INDESIT company

Model type:
A33VEX

Commercial code:
F026478

n1040294: INTRODUCTION OF THERMOSTAT AND DEFLECTOR TO IMPROVE THE DRYING PROCESS

n1040228: Replacing the belt.

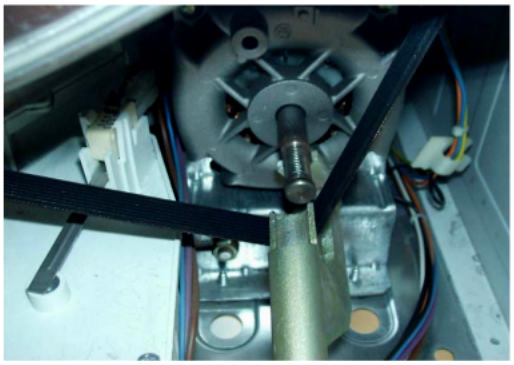
To replace the belt, perform the following instructions:
1) Check that there are no rubber residues in the motor pulley (photo 1).
2) Position the dryer on its front, remove the back panel and check that the basket opening lip is positioned correctly see photo 3 and 4.
3) Remount the belt and check that it is positioned correctly on the motor pulley (1-2 slots from the bottom), perform one complete turn of the basket by hand to stabilize the belt positioning.

NT006800

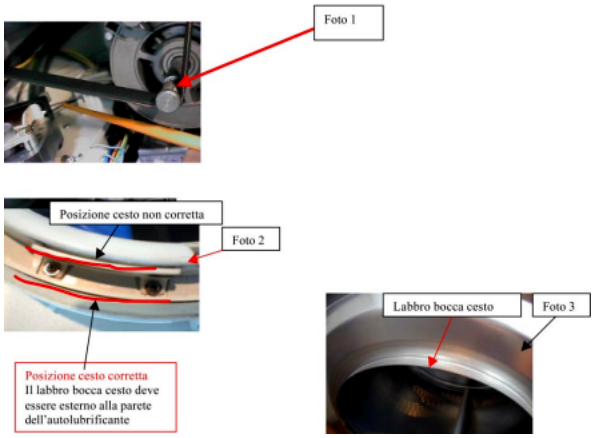
The deflector (Sat code 094507) and thermostat (47°) (Sat code 770038) have been introduced on the Dryers with square door in place of premodification thermostat (70°) (sat code 770360), to improve the drying process.
The models affected by this modification are:
A33VEX commercial code 26478;
A33VUK commercial code 26757;
A33VEX50/60 commercial code 26479;
A33VAUS commercial code 26480;
A33VEX commercial code 26481.
Pictures N1040294FIG1 - N1040294FIG2 - N1040294FIG3 - N1040294FIG4 - N1040294FIG5 show how to assemble the items mentioned above.

N1040294FIG1

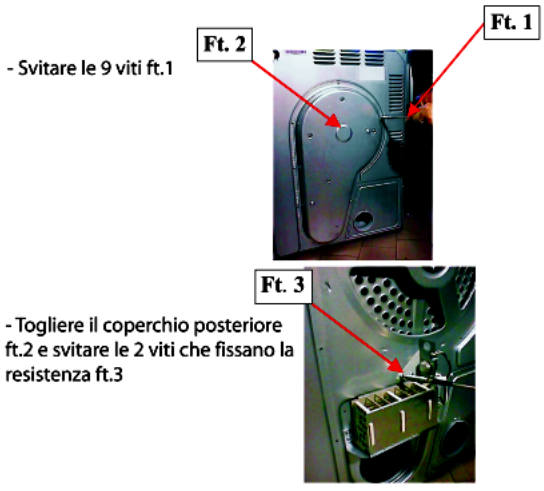
MONTAGGIO DEFLETTORE CODICE SAT 094507

N1040294FIG4

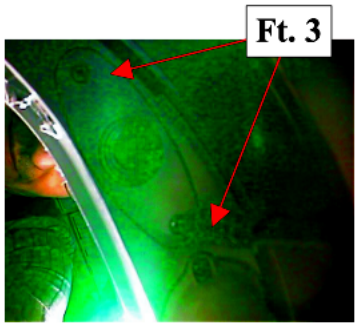
-Svitare le due viti del supporto termostato ft.3

Cod. 15216.01

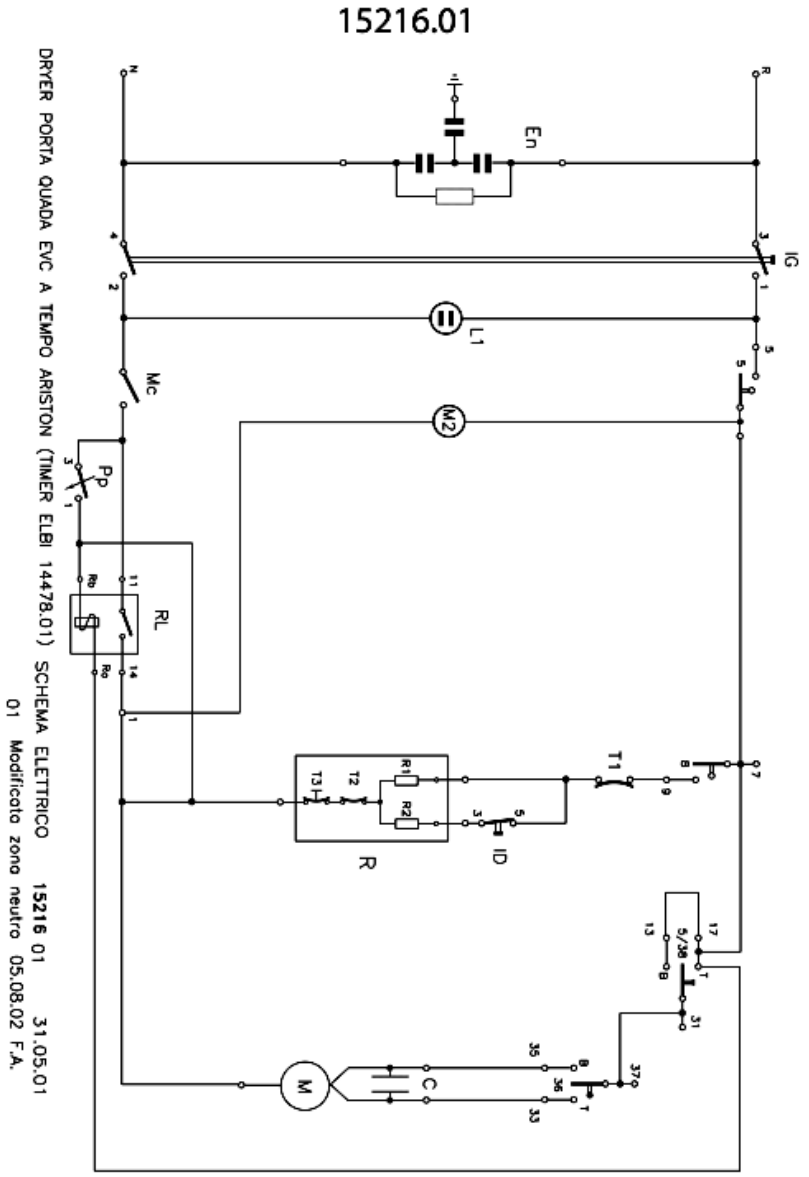
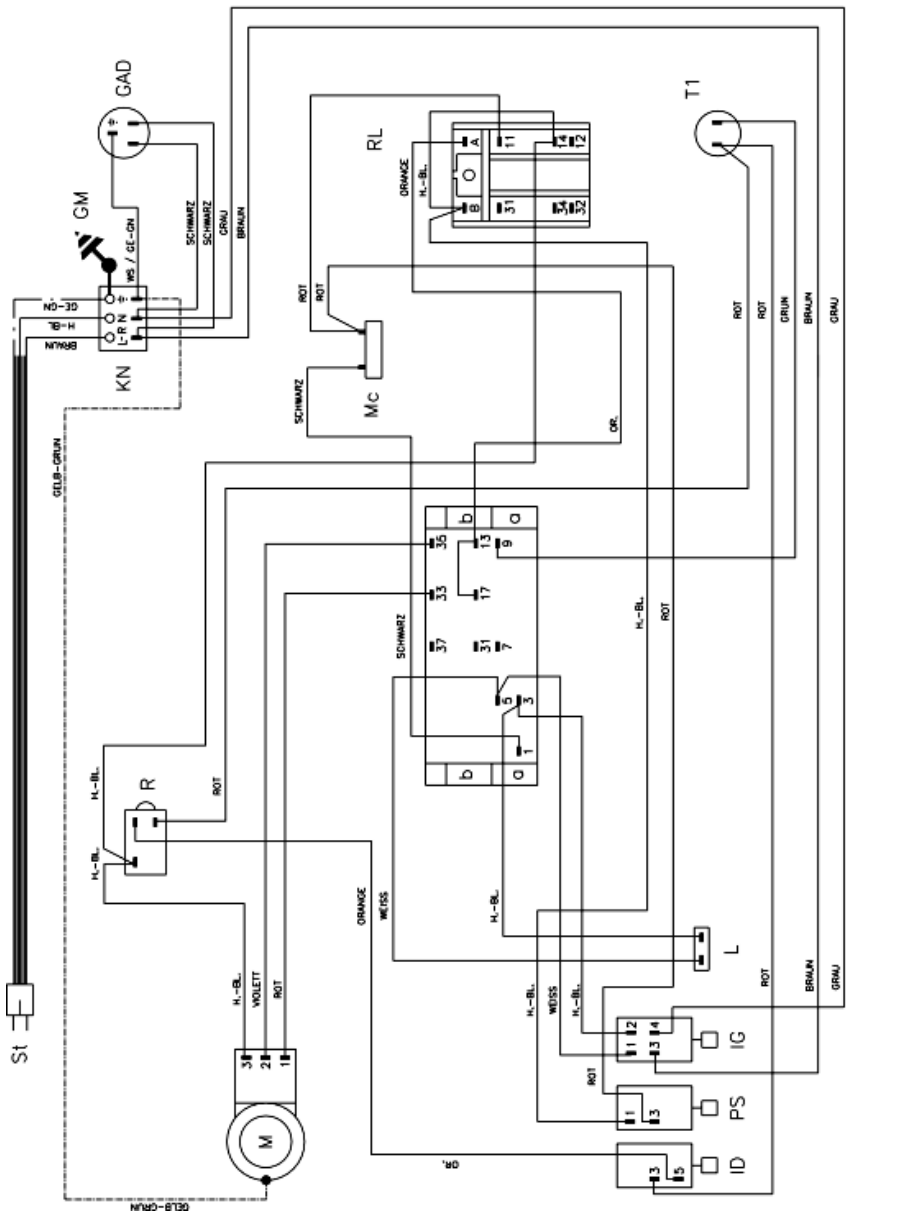
A33VEX50/60 (commercial code 26479)
A33VUK (commercial code 26757)
from serial no. (IAR) UA0133B01027 (FEBRUARY 2003), the new timer 14478.01 spare part code 092886 has replaced timer 14478 spare part code 770293.
There are two types of 14478.01 timers stocked in the Spare Part Warehouse for spare part code 092886: a "brown" type produced by ELBI and a "white" type produced by INVENSYS, which do not have the same contacts but are pin-to-pin compatible.
New and premodification diagrams are illustrated in the documentation of the various models affected.
Wiring diagram:
- New 15217.01
- Premodification CE036800
Functional chart:
- New 15216.01
- Premodification SE096000
